TRANS/WP.29/GRSG/2000/14
20 July 2000

World Forum for Harmonization of Vehicle Regulations (WP.29)

Working Party on General Safety Provisions (GRSG)

**PROPOSAL FOR A DRAFT CORRIGENDUM TO REGULATION No. 66
(Strength of superstructure)**

Figures 1(a) and 1(b), amend to read:

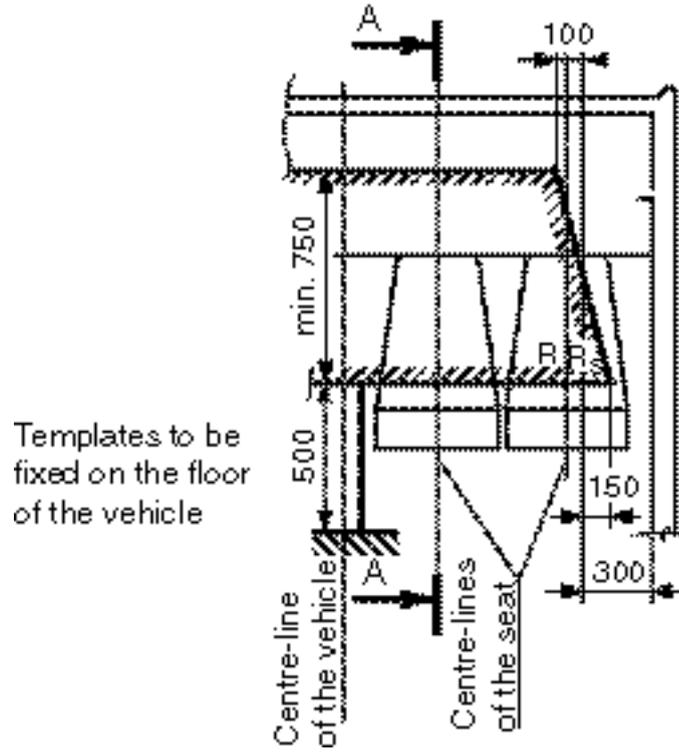
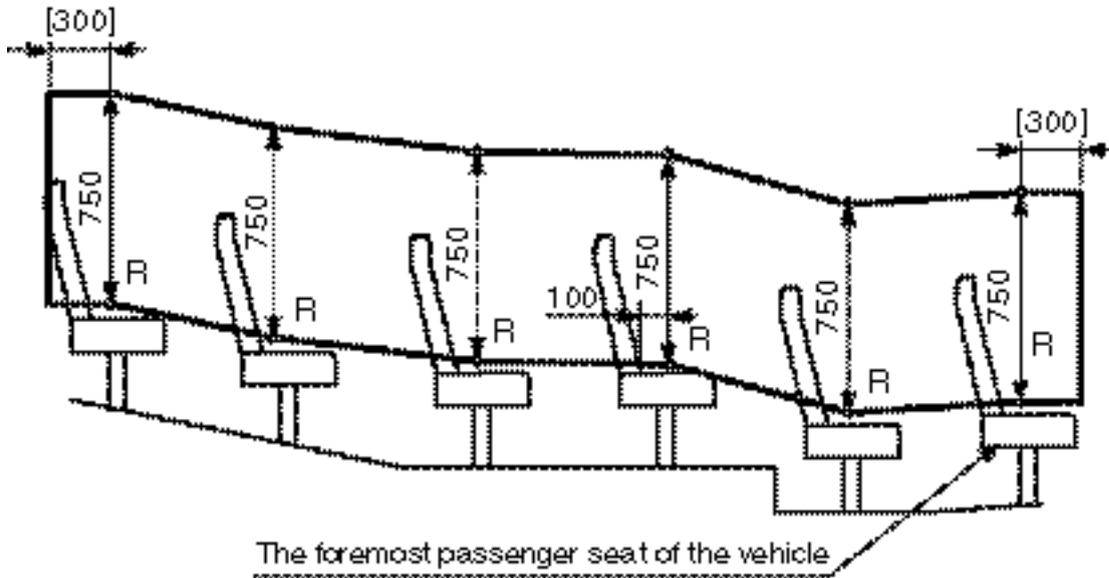
"7.1. The position of the "R" point shown in figure 1(a) shall be assumed to be 500 mm above the floor under the passengers' feet and 100 mm in front of the seat-back surface, measured in the centreline of the outboard seats. "R_s" point situated on the transversal line through the point "R" and 300 mm from the inside surface of the vehicle sidewall, is decisive for the size definition of the residual space in form of a trapezoid, see figure 1(a)."

"7.2. For the purposes of paragraph 5.1. of this Regulation, the residual space means the volume within the passenger compartment which is swept when the transversal vertical plane defined in figure 1(a) of this Regulation is moved in a straight line or lines so that the point "R" in figure 1(b) passes from the "R" point of the rearmost outer seat, through the "R" point of every intermediate outer seat to the "R" point of the foremost outer passenger seat. The residual space exceeds the distance of that extreme "R" point by two horizontal overhangs of length [300] mm each."

If the moving transversal basic plane is vertical in compliance with the wording of the new paragraph 7.2., then the points where that upper line changes its direction must be situated exactly above all the "R" points (and not in the direction of the reference torso line. Additionally, two missing vertical segments of the border-line on the place of the initial and the last "R" point should be added in fig. 1(b). However, the best solution for the passengers would be if the length of the residual space could be still enlarged by horizontal overhangs of about 300 mm on each of its ends. In fig. 1(b) it was not indicated how to measure the 100 mm distance of "R" point from the seat-back surface.
